Docket Item #s1 & 2
BAR CASE # 2011-0006 &
2011-0007

BAR Meeting
February 2, 2011

ISSUE: Permit to Demolish and Alterations (new entrance and dormer)

LOCATION: 427 North Lee Street

Figure 5. Proposed partial demolition – east roof slope

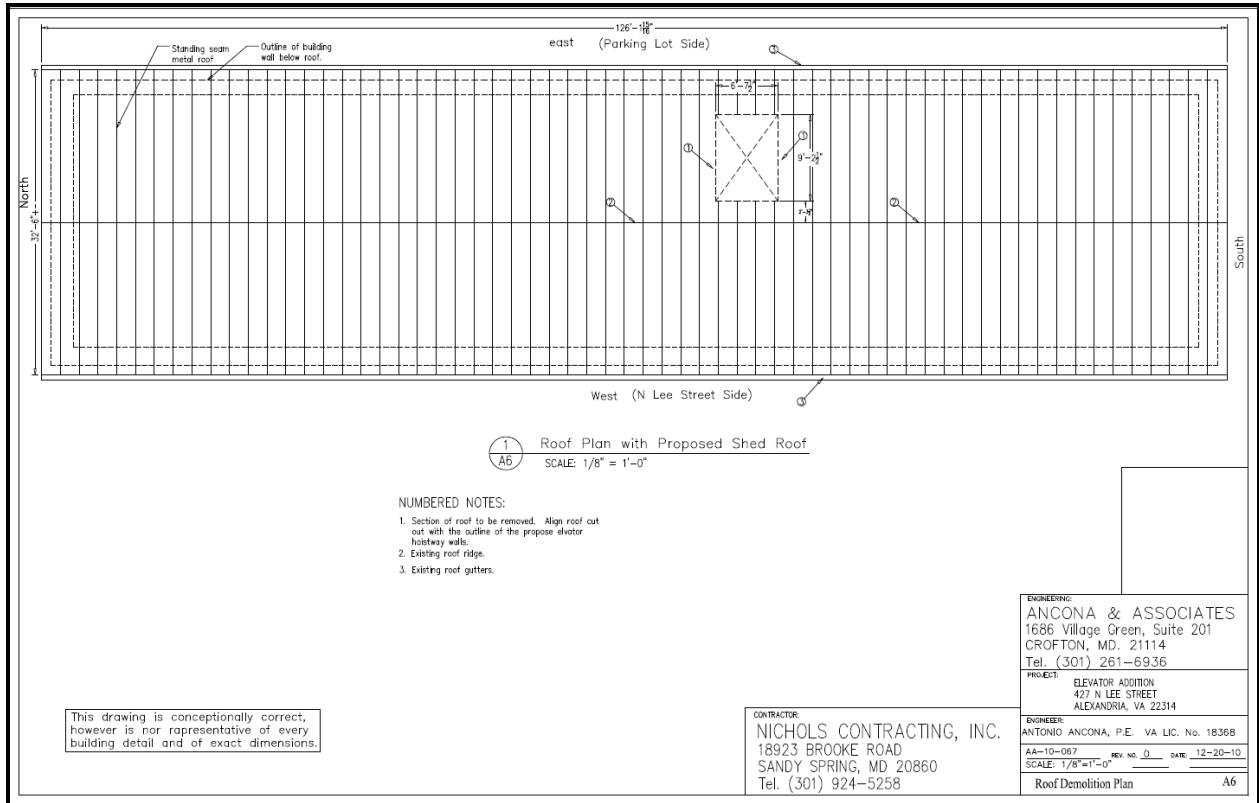
A 6'-7.5" by 9'-2.5" portion of the east slope of the gable roof will be demolished in order to construct a dormer to provide adequate ventilation for the hoistway associated with the new elevator being installed in the building. The total area of demolition is approximately 61 square feet.

In the opinion of Staff, none of the criteria for demolition are met and the Permit to Demolish should be granted. The area proposed for demolition is minimal, and is located on the secondary, less prominent roof slope. Furthermore, although a portion of the building may date from the 19th century, the roof – as well as the fenestration on the building - is clearly a late 20th century feature. No character defining features of uncommon design or historic merit are impacted, nor do the small areas of demolition compromise the integrity of the building as a whole.

Figure 6. Proposed dormer.

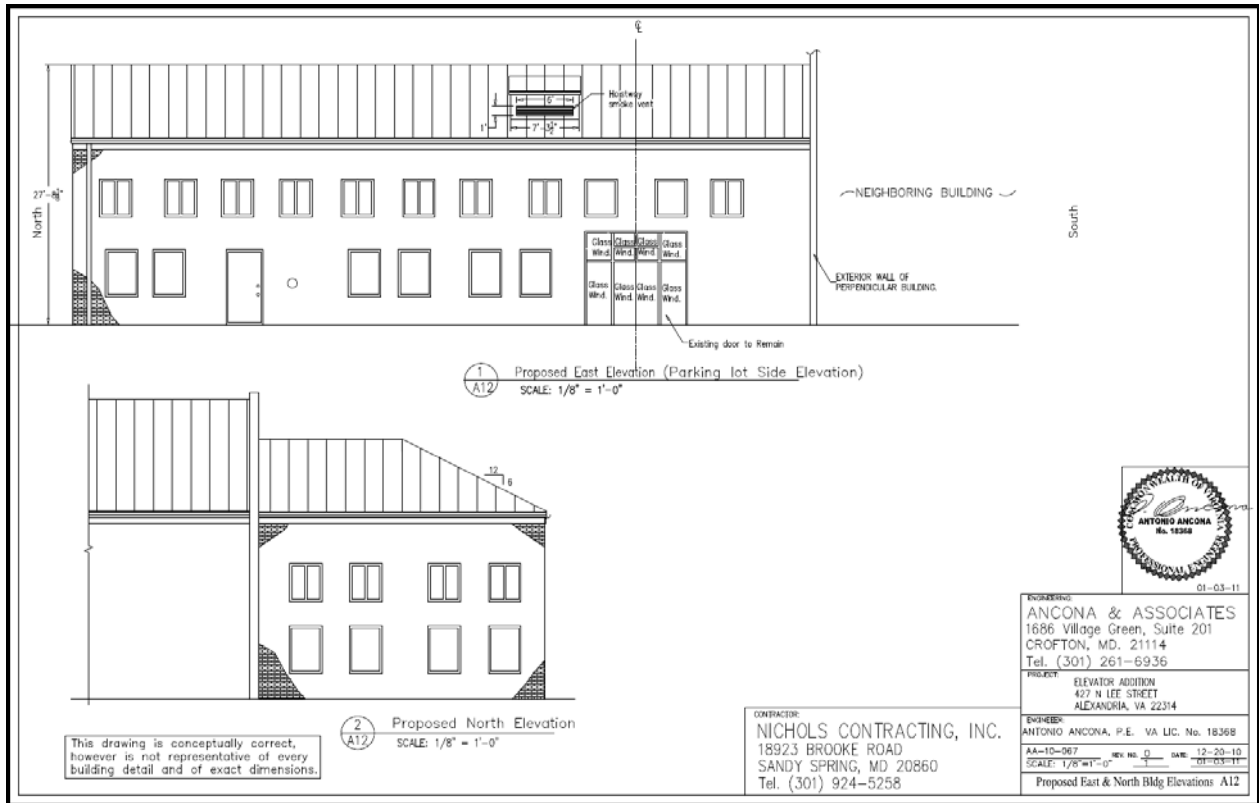
The proposed new rooftop shed dormer will have a low 2:12 slope roof and will measure 7'-3.5' wide by 2'-7.5" high. There will be a 1' horizontal vent on the face of the dormer. The dormer will match the existing roof in both material and color.

Staff has no objection to the proposed dormer and storefront entry system. The elevator is necessary to make the building ADA compliant and will have a relatively minor impact on the exterior of the building. The low slope of the shed dormer, as well as the matching roof material and color, will make it minimally visible.

Figure 7. Proposed west elevation.

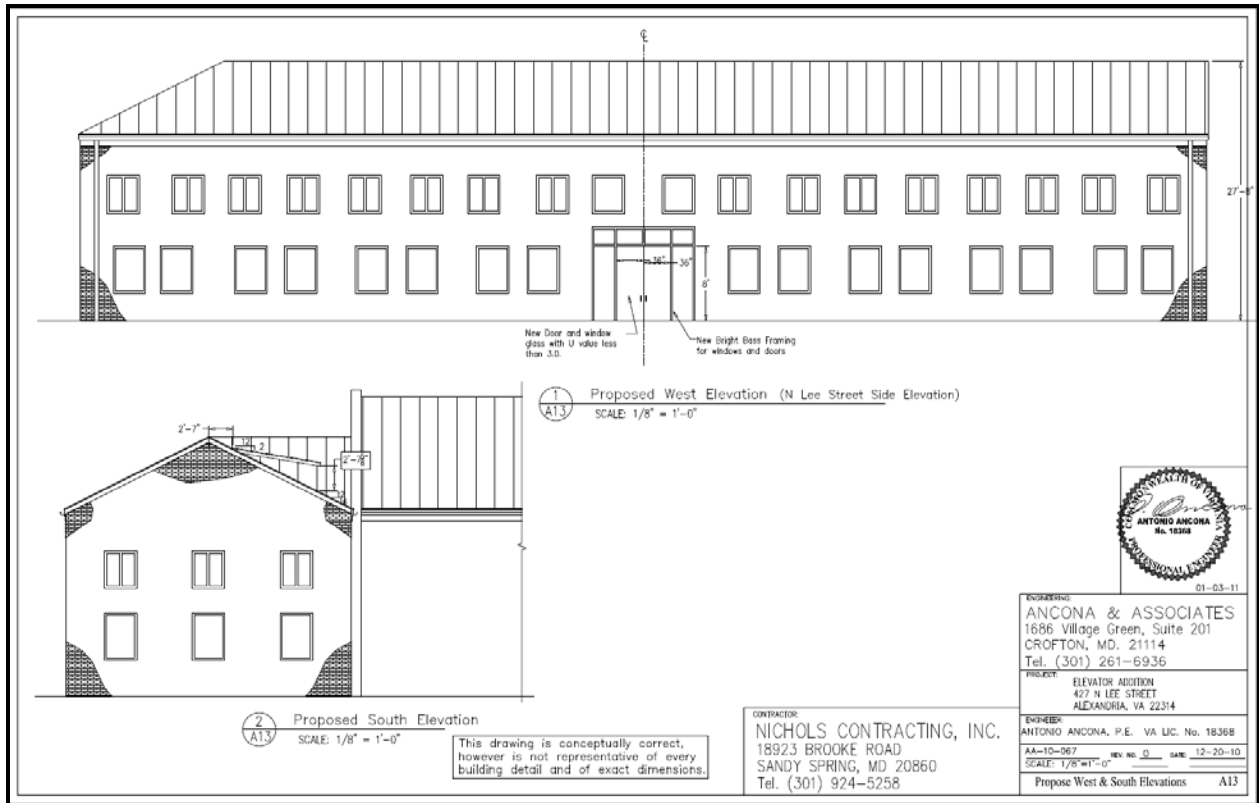
Alterations to the building consist of changing the existing fixed aluminum storefront window system on the west elevation to a new entrance. The new storefront will be constructed of bright polished brass and will have double doors flanked by full light sidelights and a transom. The same storefront system was originally proposed for the east elevation, but the applicant has since withdrawn that request.

While Staff supports the installation of doors on the North Lee Street elevation (the two steps up to this opening suggest that it was an entrance in the past) the material selected by the applicant – polished bright brass – contrasts starkly with the existing dark bronze anodized aluminum window and door frames throughout the Lee Street Square development. While understanding the need to differentiate and identify the building entrance on this façade, Staff recommends that the new storefront system be constructed of either dark aluminum to match the existing adjacent storefront windows or from another high quality material which will be visually compatible with the rest of the office complex, such as oiled bronze.

STAFF RECOMMENDATION: Staff recommends approval of the Permit to Demolish and the Certificate of Appropriateness for alterations with the condition that the applicant work with Staff to find a darker material for the new North Lee Street entrance so that it will be more compatible with the existing dark aluminum windows and doors on the building.
